CITY OF ST. AUGUSTINE HISTORIC ARCHITECTURAL REVIEW BOARD

AMENDED

A G E N D A

THURSDAY, FEBRUARY 16, 2023 - 1:00 PM

NEW GARAGE FOR
JOHNSTON RESIDENCE
320 ST. GEORGE ST. ST. AUGUSTINE, FL.

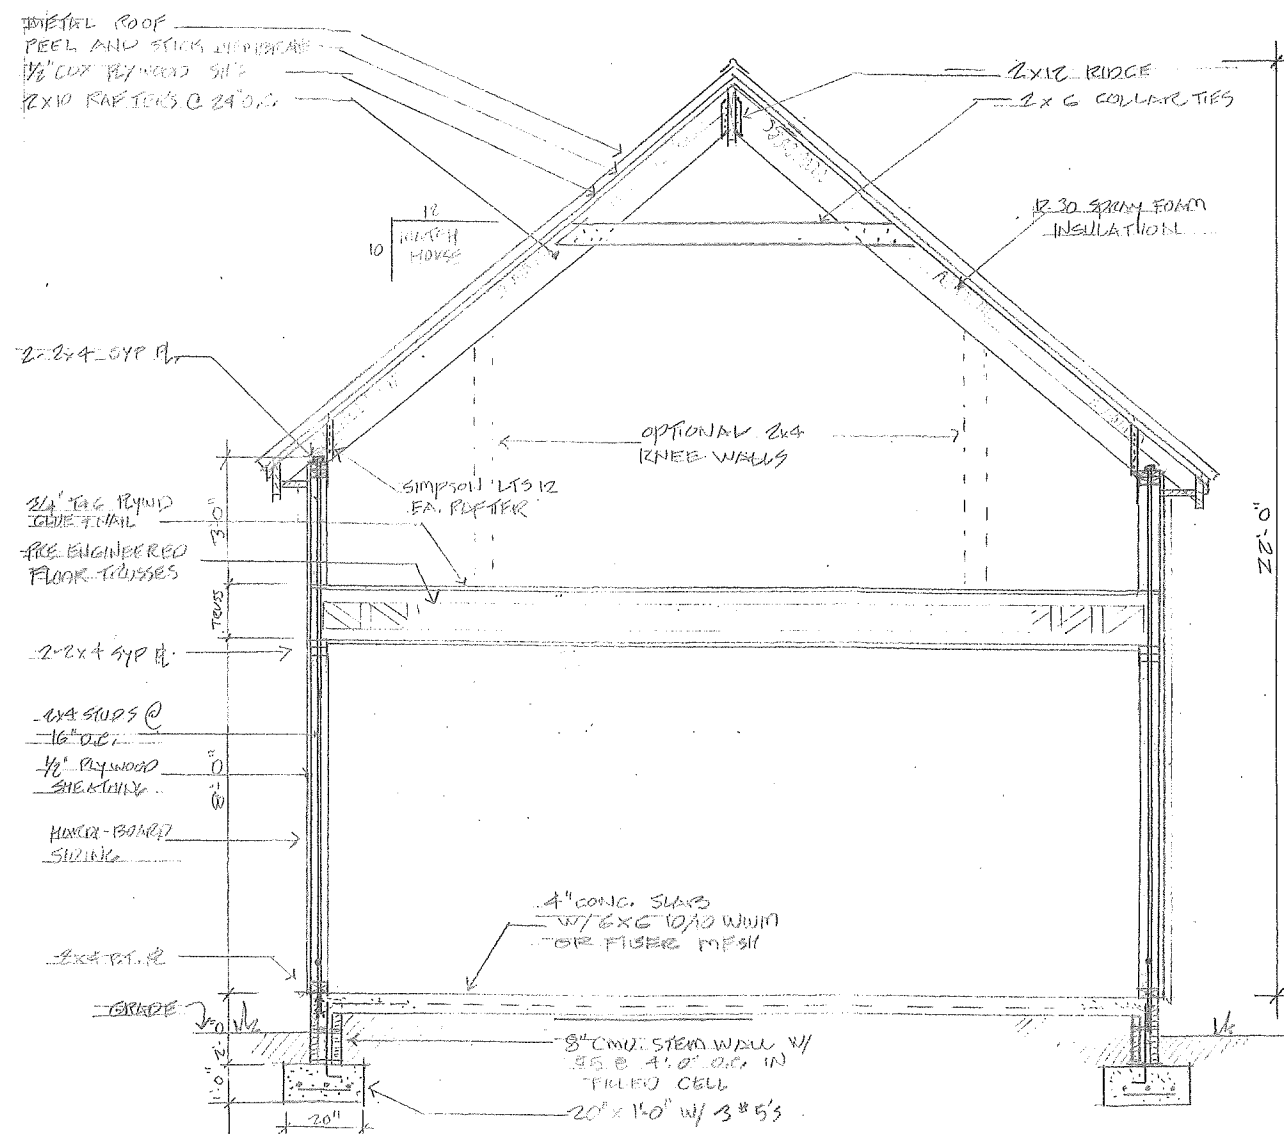
6. Decorative brackets proposed for the hipped roof overhang above the garage appear to be a Craftsman style and the spindle detail seen on the east and south elevations may not be compatible with the level of ornamentation recommended by the AGHP for accessory structures.

8. Garage doors, the entry door, and windows are proposed to be wood. It appears, based upon the submitted plans, that the garage doors are glazed. The AGHP recommends unglazed garage doors in a style compatible with the primary building. The HARB may determine that the garage doors as proposed are compatible with the architectural style of the primary building and reasonably compatible with the adjacent HP-1 zoning district.

9. Brick pavers to match the existing walkway were indicated as the preferred paving material for the driveway. The applicant should clarify the pattern and material of the bricks. The AGHP allows for stone or clay brick pavers on sand. An alternative material may be appropriate if it mimics an appropriate paver in size, shape, texture and color.

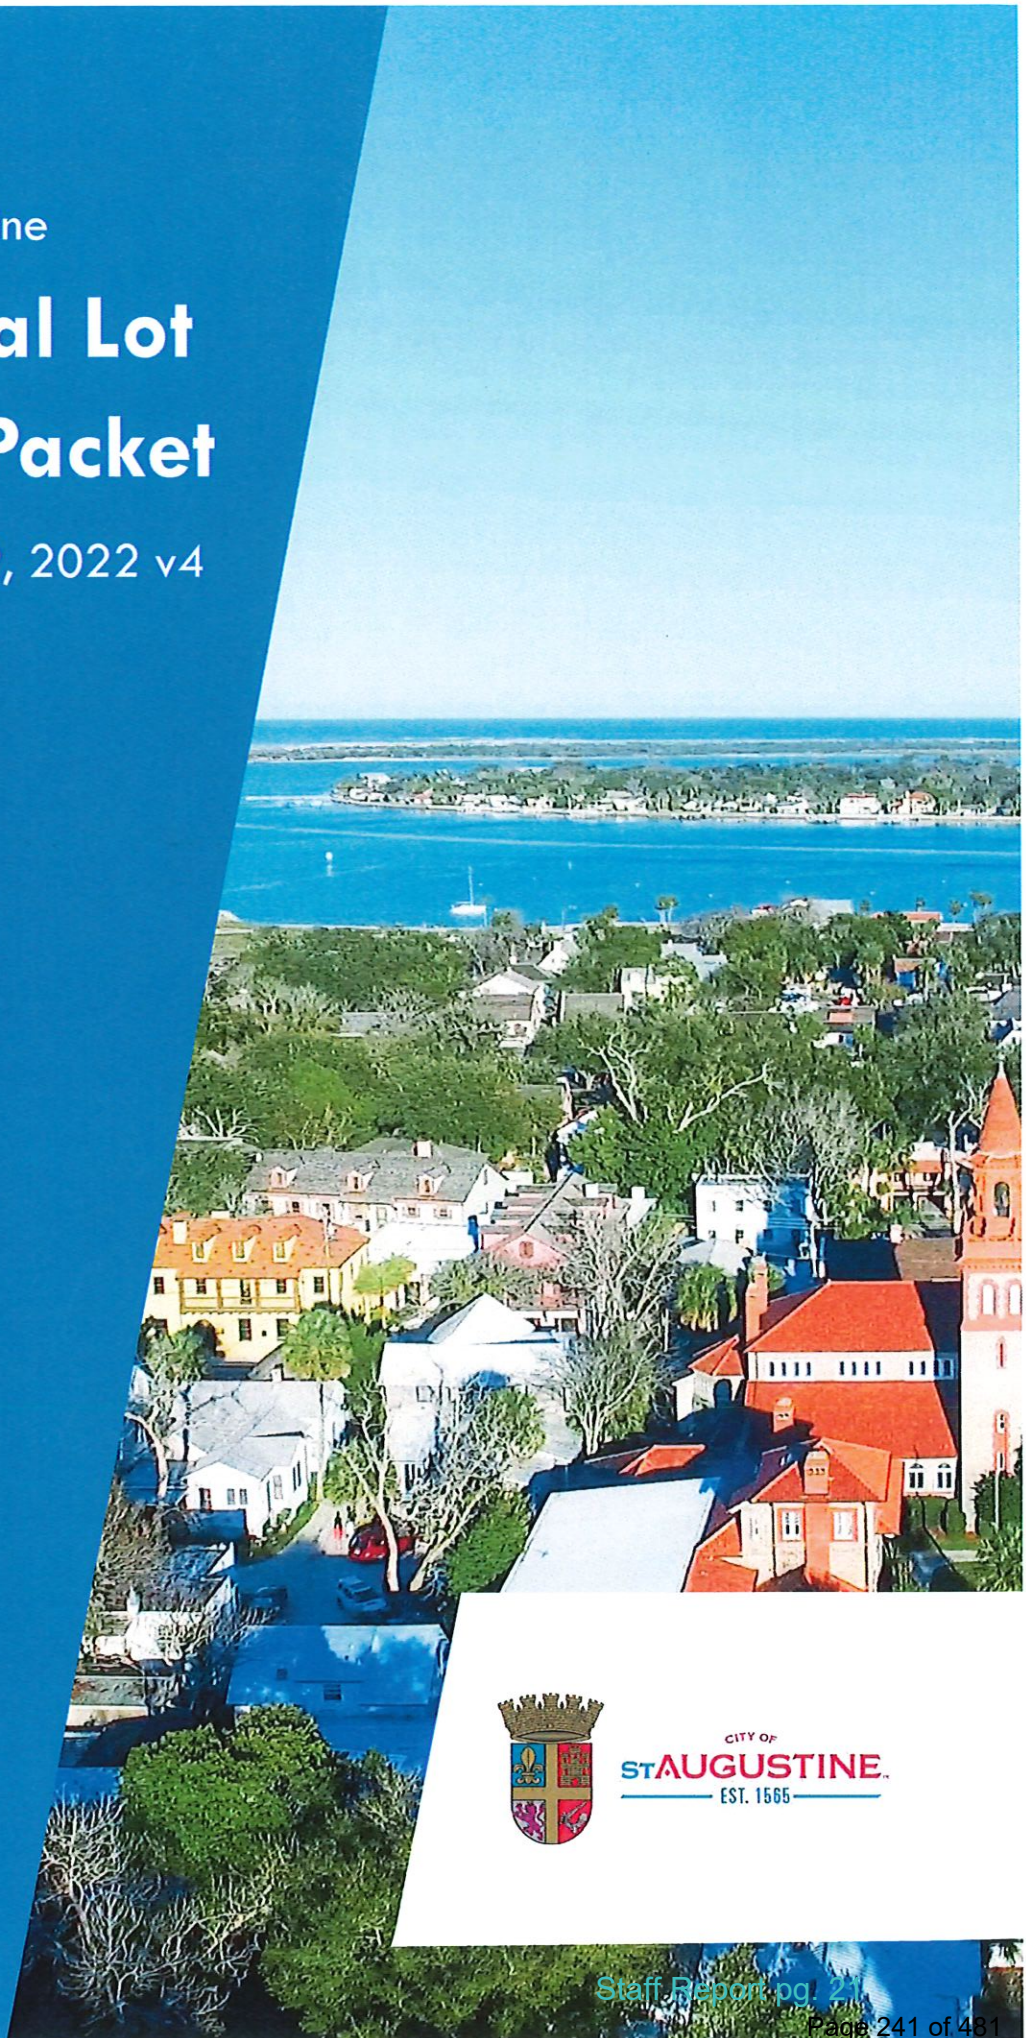
1. Finished floor elevations and grading plan should be shown for both lots.
 - a. Grading plan must show existing adjacent lot grades a minimum of 10-feet beyond the property line. The proposed development must clearly demonstrate that adjacent properties will not flood due to proposed grade changes.
2. Please see provided residential stormwater packet and Ordinance.

*Spoke about preference of Grading to
Flow towards Castillo Dr*
